**SUBDIVISION REVIEW SHEET****CASE NO.:** C8-2020-0255.0A**COMMISSION DATE:** March 2, 2021**SUBDIVISION NAME:** Avery Lakeline Final Plat**ADDRESS:** 14121 N US Hwy 183**APPLICANT:** Lakeline Avery Partners, LP (Alex Clarke)**AGENT:** John A. Alvarez, P.E. (Jones-Carter, Inc.)**ZONING:** CH-CS-MU-MF-4**AREA:** 97.21 ac.**LOTS:** 8**COUNTY:** Williamson**DISTRICT:** 6**WATERSHED:** Buttercup Creek & South Brushy Creek**JURISDICTION:** Full Purpose**SIDEWALKS:** Sidewalks will be constructed along Avery Ranch Blvd, North Lake Creek Parkway and Hema Dr.**DEPARTMENT COMMENTS:**

CITY OF AUSTIN –DEVELOPMENT SERVICES DEPARTMENT  
SUBDIVISION APPLICATION – MASTER COMMENT REPORT

CASE NUMBER: C8-2020-0255.0A  
UPDATE: U0  
CASE MANAGER: Joey de la Garza      PHONE #: 512-974-2664

PROJECT NAME: Avery Lakeline  
LOCATION: 14121 N US 183 HWY

REPLAT OF AVERY LAKELINE

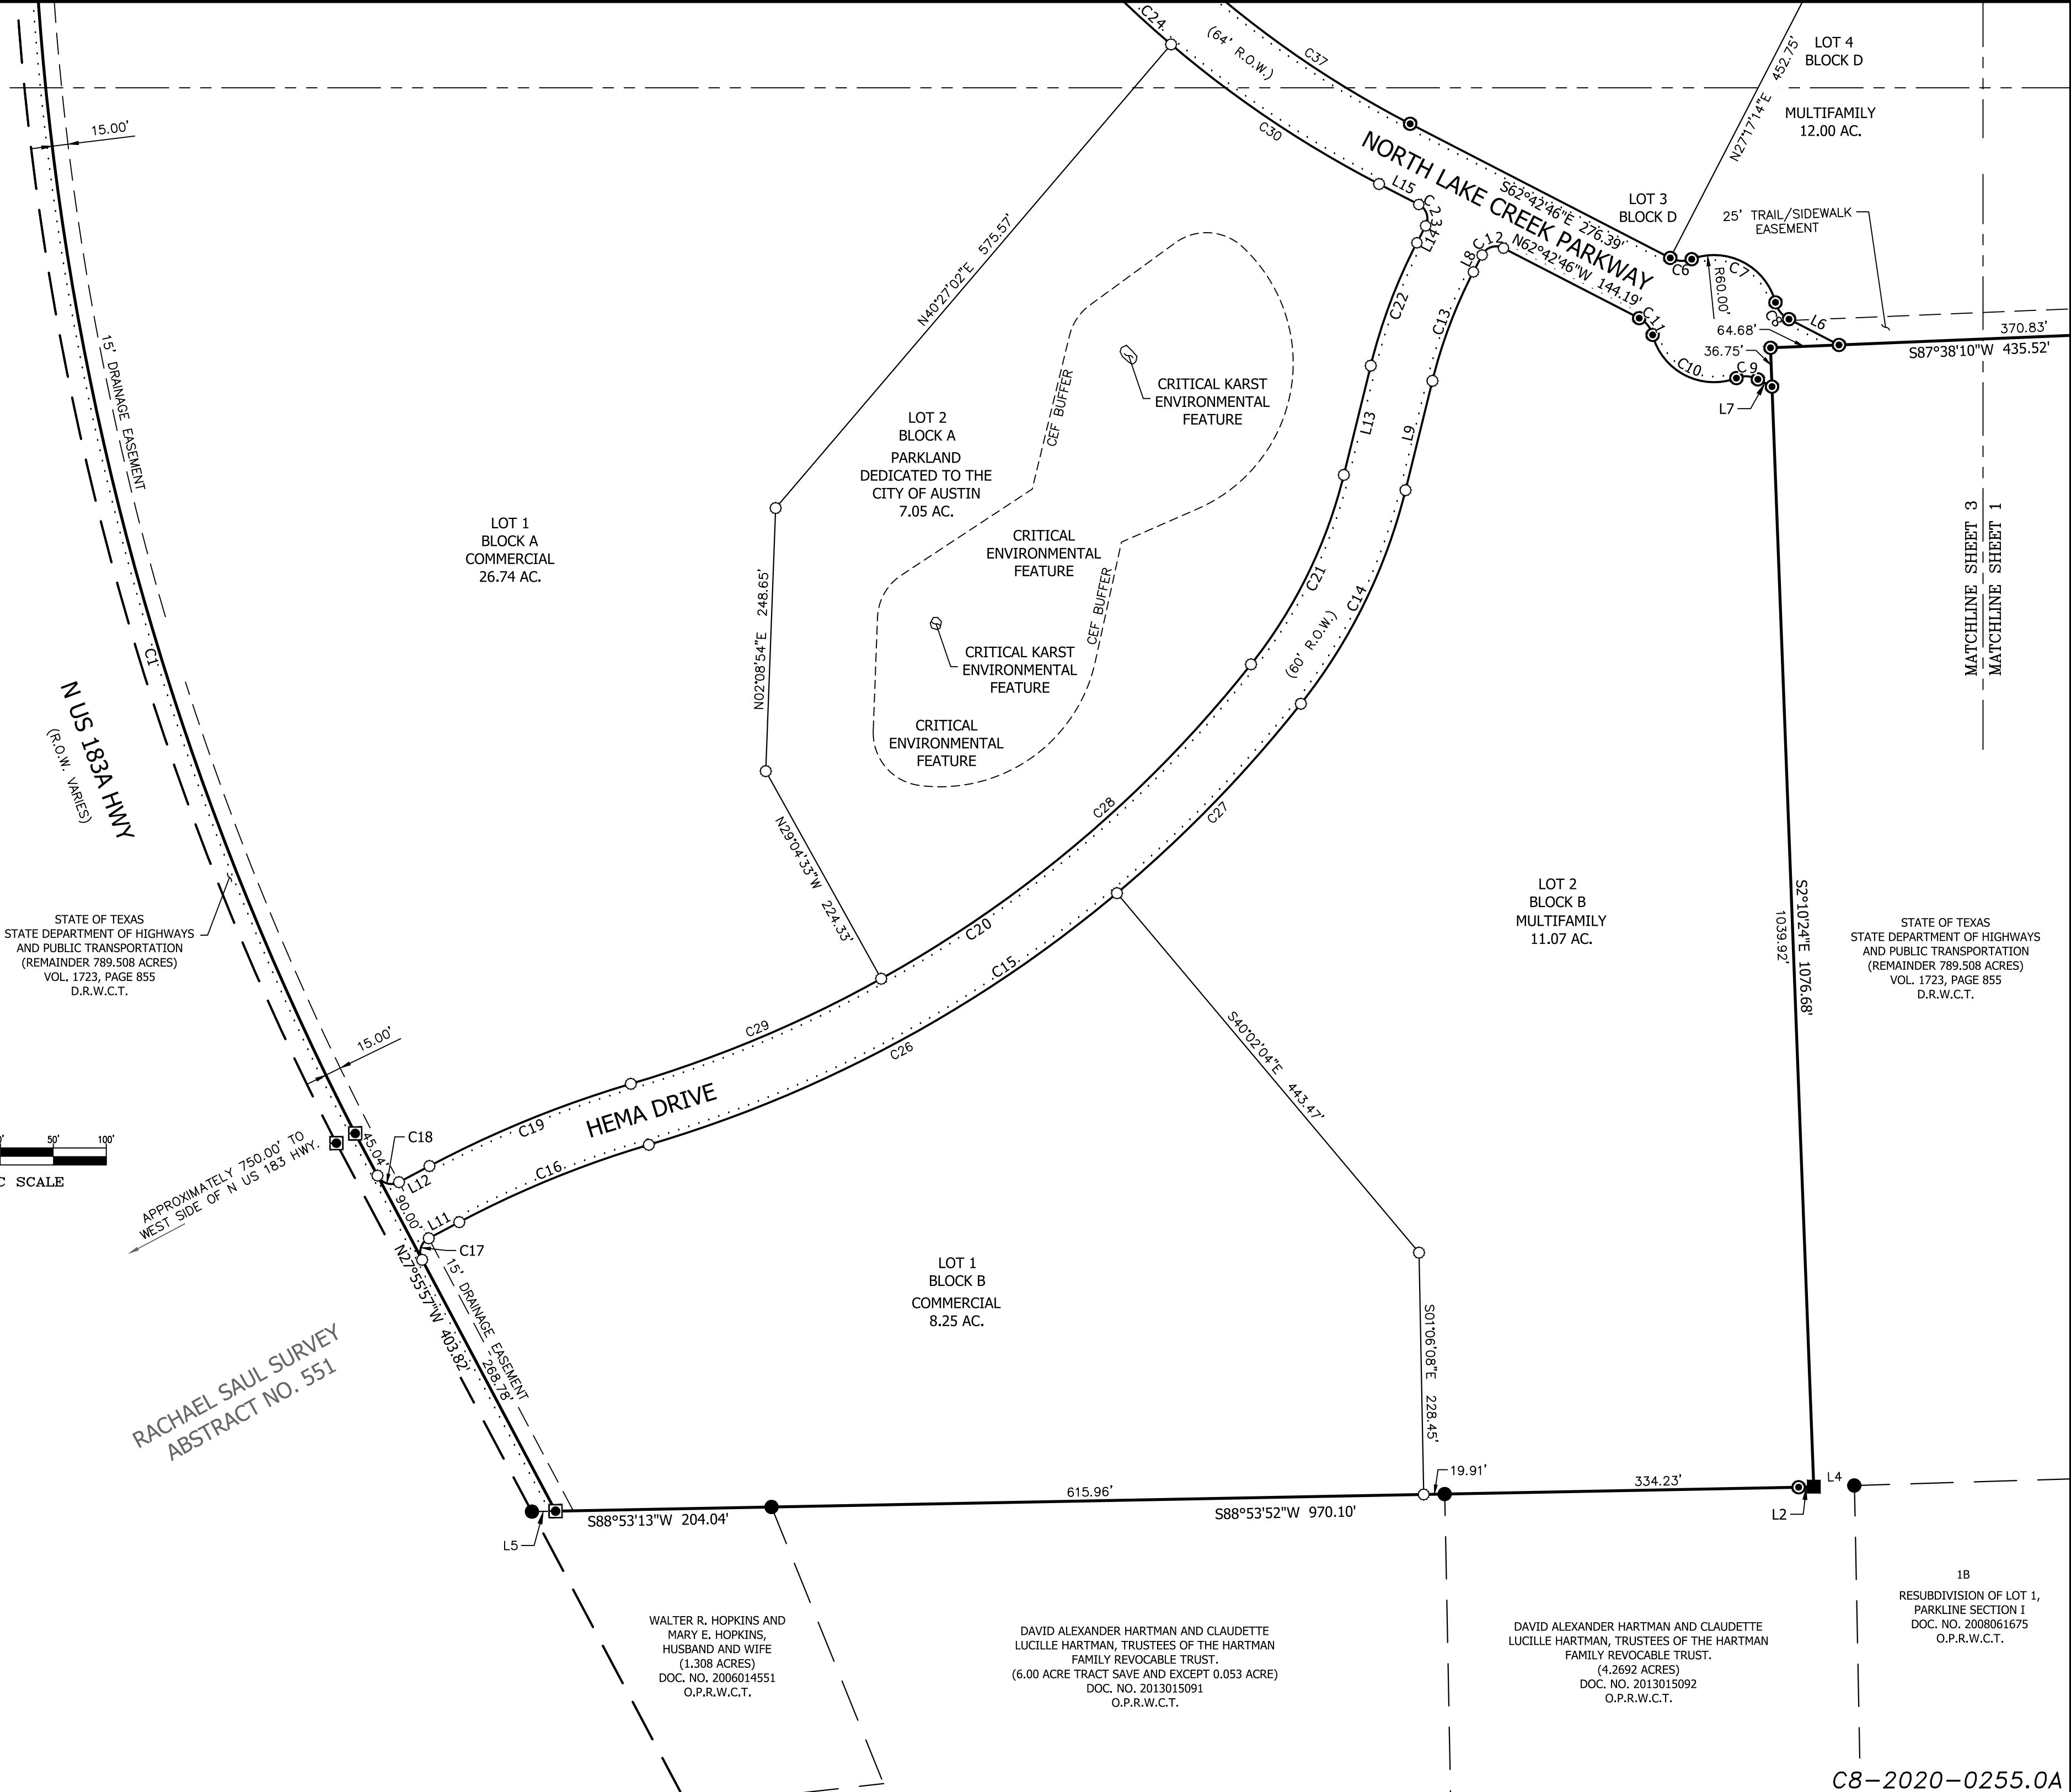
DE 1 Engineer's seal, signature and date required [LDC 25-7-62].

DE 2 Add the following Floodplain Note: "No portion of this tract is within the boundaries of the 100 year floodplain according to data from the Federal Insurance Administration FIRM panel # \_\_\_\_\_, dated \_\_\_\_\_ for \_\_\_\_\_ (name of city or county)."

- SR 1. Add the Case # C8-2020-0255.0A in the bottom right hand corner of each sheet. 25-1-83
- SR 2. Add the following note 25-1-83; TXLCG 212.016; 2122.014: "All restrictions and notes from the previous existing subdivision, Avery Lakeline, recorded in Doc. No. 2020023739 of the plat records of Williamson County, shall apply to this plat."
- SR 3. There are two owners of the property which comprise this plat, Lakeline Avery Partners, LP and Ascension Seton. Please revise the Owner's dedication statement as follows to reflect this: 25-1-83

- SR 4. Provide documentation that <name>, <title>, has the authority to sign the plat as owner on behalf of Ascension Seton. 25-1-83
- SR 5. Add an owner signature block for Ascension Seton under the Owner's Statement. Show signatures of owner(s), notary public(s) with appropriate, legible seals and dates. Print names under signatures with addresses. 25-1-83
- SR 6. Please amend the following administrative approval block: 25-1-83  
 APPROVED, ACCEPTED AND AUTHORIZED FOR RECORD BY THE DIRECTOR, DEVELOPMENT SERVICES DEPARTMENT, CITY OF AUSTIN, COUNTY OF TRAVIS, THIS THE \_\_\_\_ DAY OF \_\_\_\_\_, 20\_\_, AD.

- SR 7. Remove the existing Zoning and Platting Commission approval block on the plat and replace it with the Land Use Commission approval block as follows 25-1-83:
